General machining tolerances UNI 5307-63								
Dimensions	< 6	6-30	>30-120	>120-315	>315-1000	>1000-2000	>2000-4000	>4000
Linear Toli.	± 0.1	± 0.2	± 0.3	± 0.5	± 0.8	± 1.2	± 2	± 3
angular Toli.	± 1'		± 30'	± 20'	± 10'			
referred to the shortest side								
designed for								
R.De Salvo								
draw. by								
G. Gennaro-PROMECC								
date								
30-12-04								
scale								
1/1								
title								
HAM-OPTICAL BENCH								
DETAILS FILTER								
detail								
from 105-106								
A 2

26

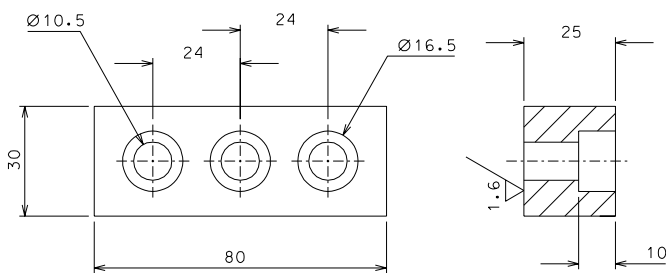
modified detail 26				09-04-06	
modified n° parts of detail 28				10-02-06	
ref.	note	date	signature		
modifications					
28	32	AISI 304	1/1		
27	32	AISI 304	1/1		
26	32	AISI 304	1/1		
24	32	Fe 360	1/1		
21	32	AISI 304	1/1	72	8 peek 1000 1/1
ref.	pieces	mat. and treatments	scale	ref.	pieces mat. and treatments scale
